May 11, 2018

BOARD OF COUNTY COMMISSIONERS
ORANGE COUNTY, FLORIDA

ADDENDUM NO. 4 / IFB NO. Y18-758-TA

SOUTH SERVICE AREA/EAST SERVICE AREA (SSA/ESA) 36-INCH POTABLE
WATER MAIN, 24-INCH RECLAIMED WATER MAIN AND J. LAWSON BLVD
POTABLE WATER RE-PUMP FACILITY

SCALE: AS SHOWN
DRAWING NO.:
P-102
SHEET: 149 OF 292

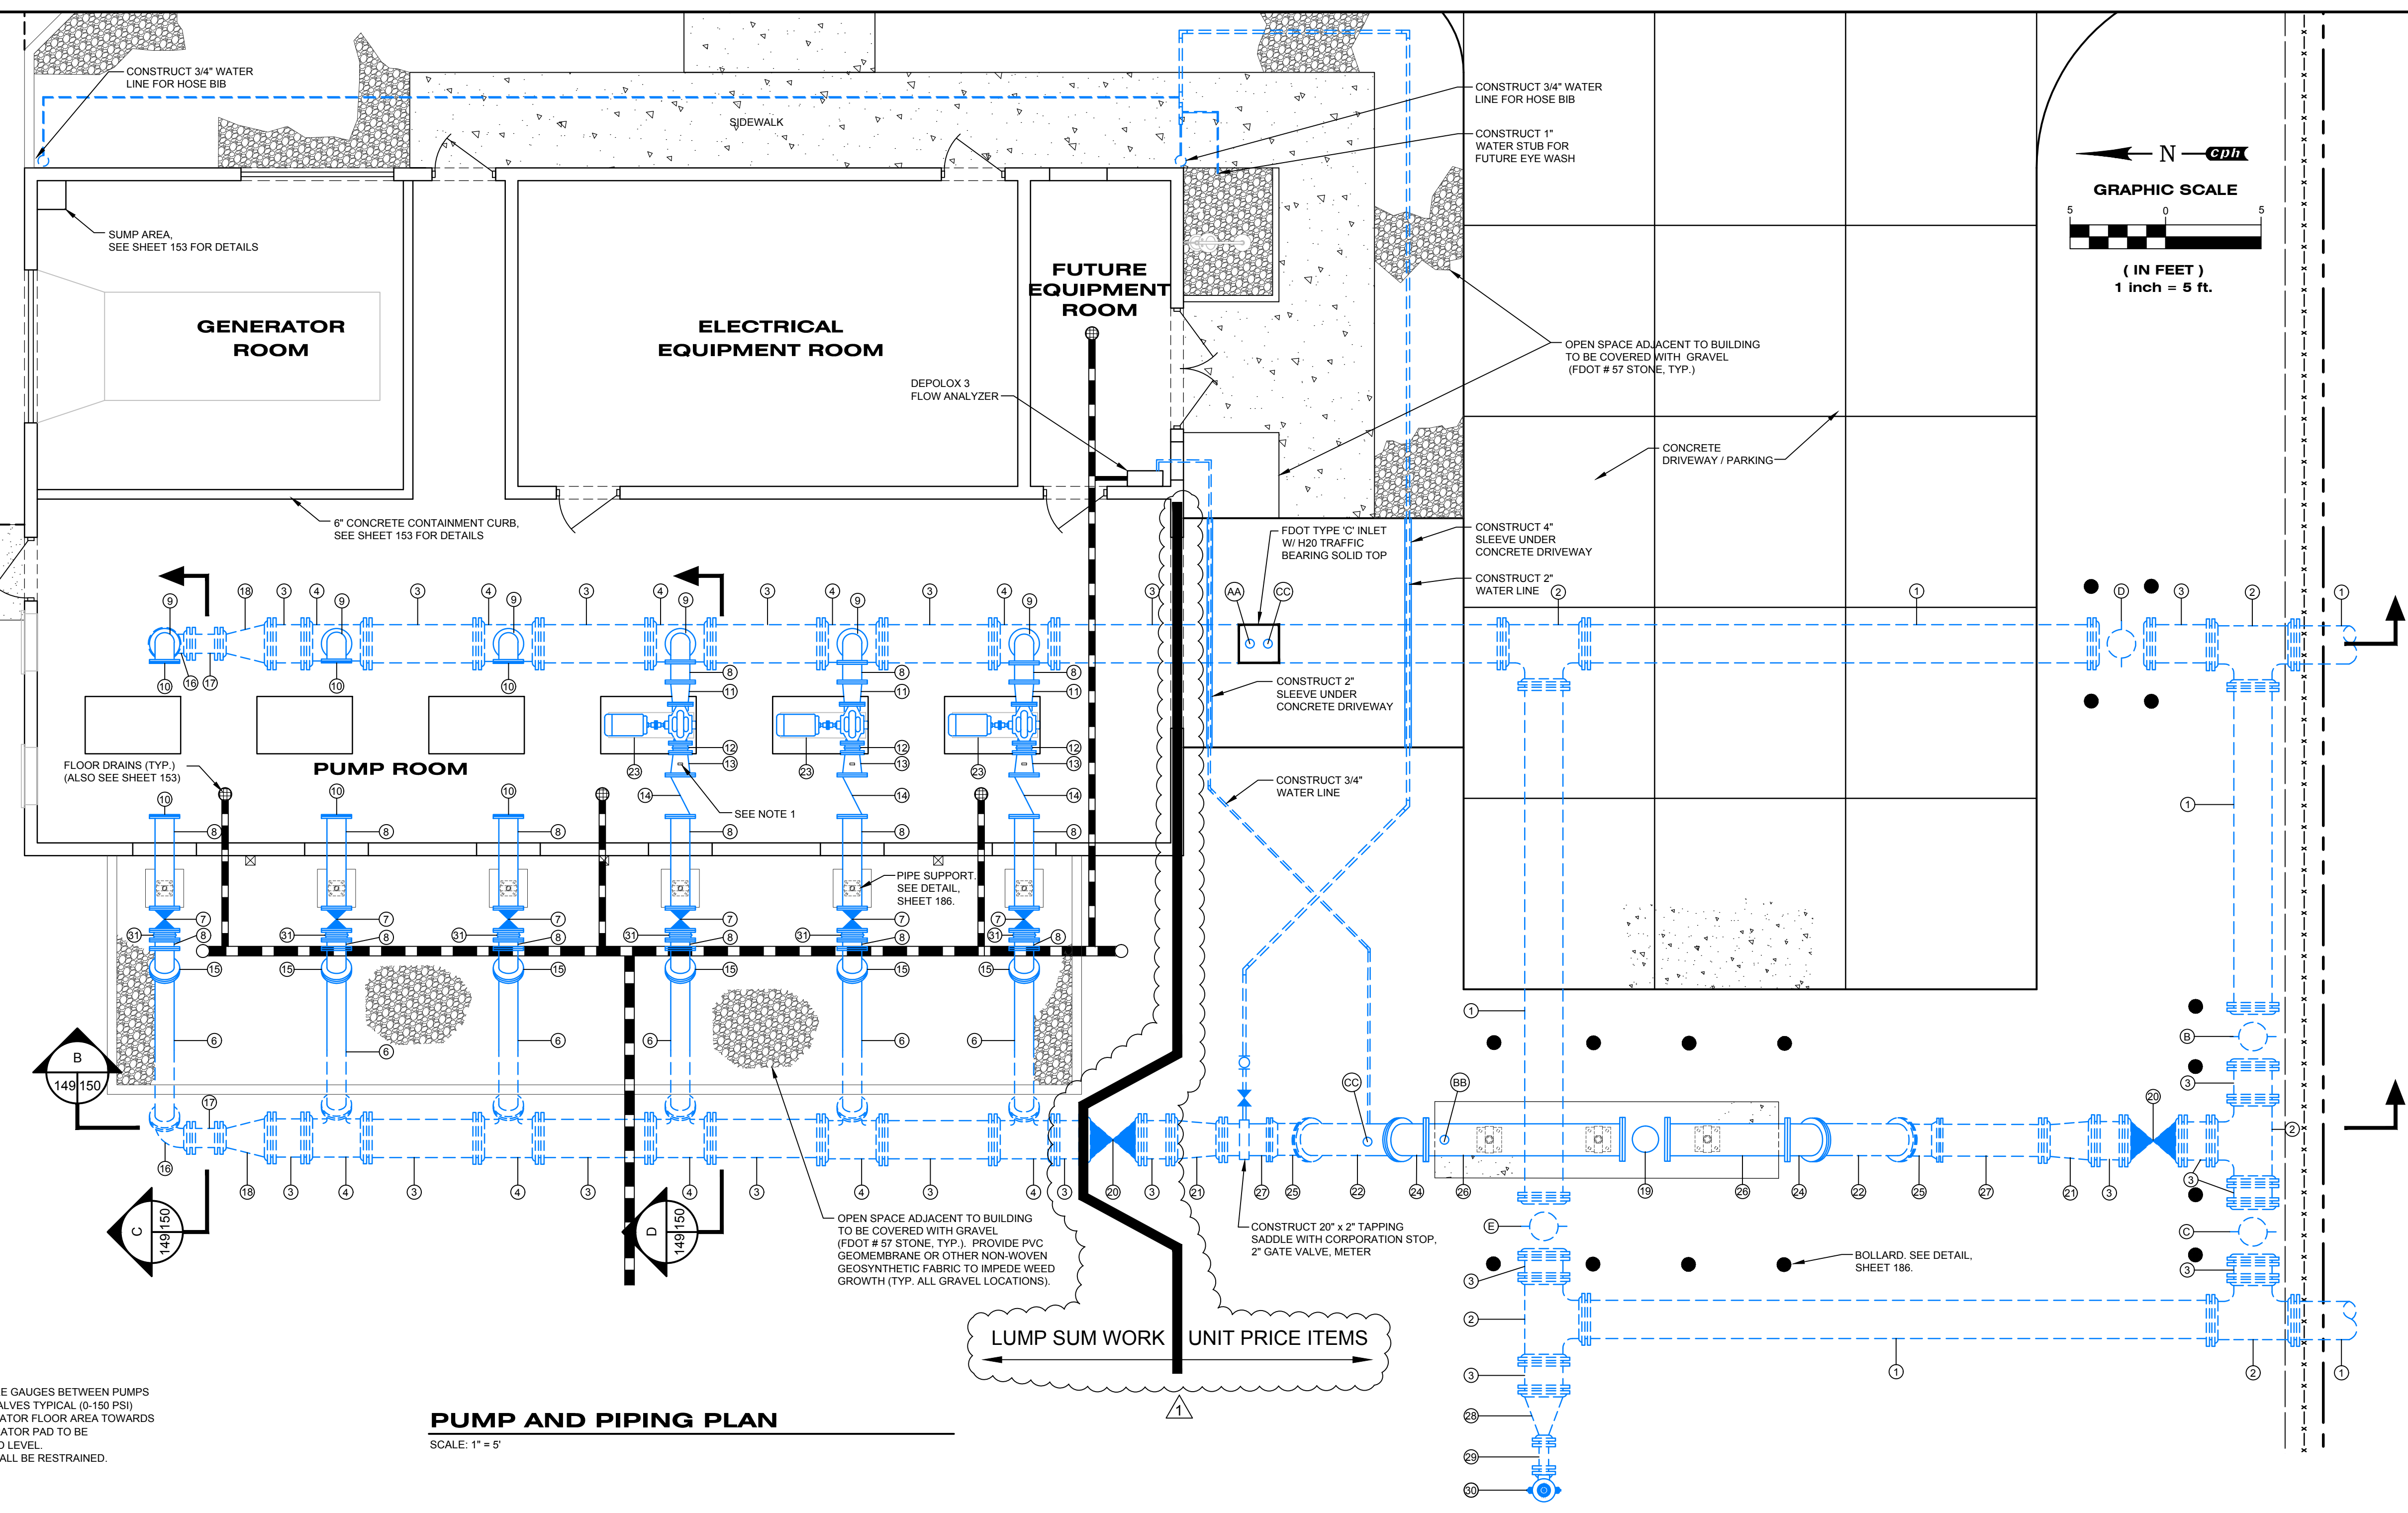
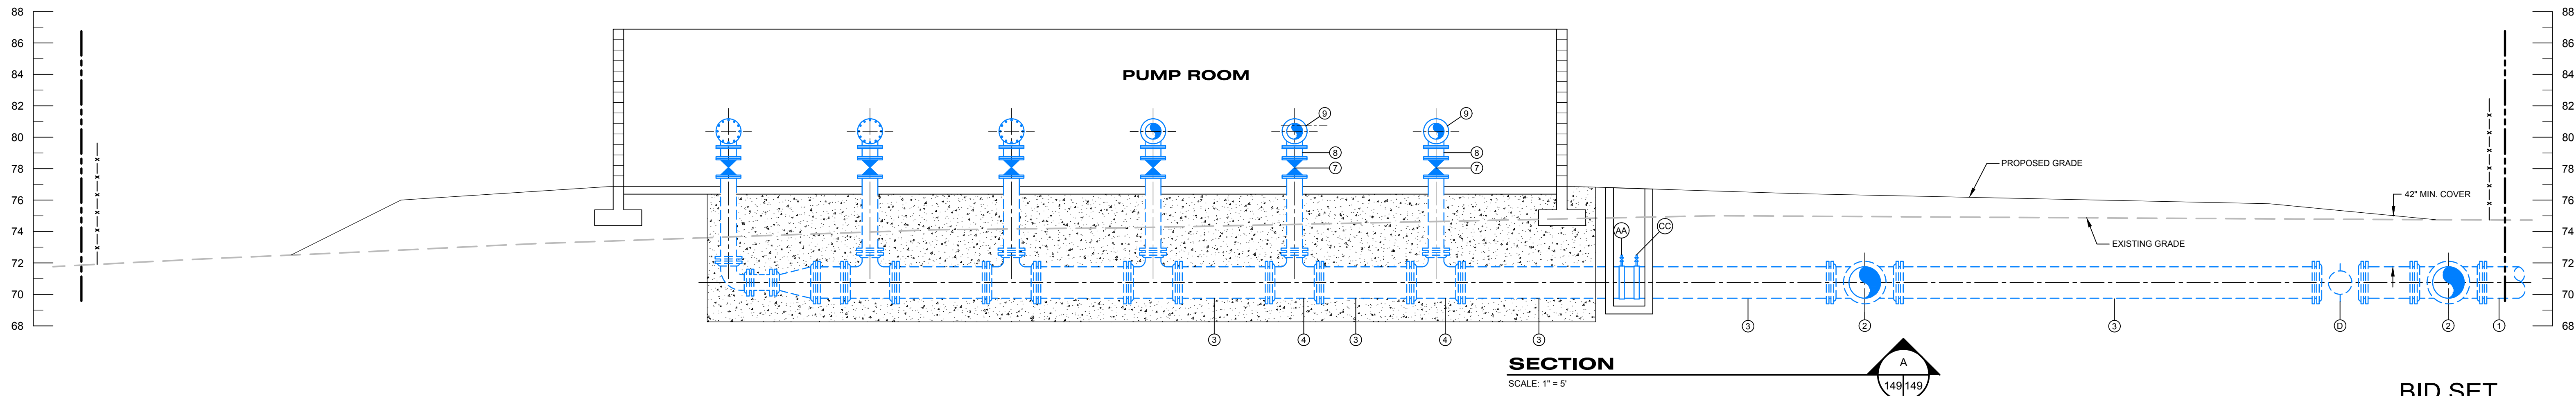
45 Q We are unable to find any buried 12" gate valves at the pump station to align with Bid Item 35, however the plans do show twelve 12" flanged gate valves, all above grade. We suggest removing Bid Item 35 and including those valves with Bid Item 66 similar to how the remainder of the above grade piping is being handled.

46 Q Bid Item 41 is for 12" check valves. Similar to the previous question, since all check valves are above grade, please consider removing this bid item and allowing these to be incorporated with all other above grade piping into Bid Item 66.

DRAWING P-102

A We are in agreement with this suggestion. Bid item 35 will be deleted. We will reissue sheet P-102 to clarify the limits of work included with lump sum pay item 66.

A We are in agreement with this suggestion. Bid item 41 will be deleted. We will reissue sheet P-102 to clarify the limits of work included with lump sum pay item 66.

Amend: Delete drawing P-102 and replace with the revised drawing P-102. The revised drawing displays the separation of the lump sum and unit price items for the Re-Pump Station.
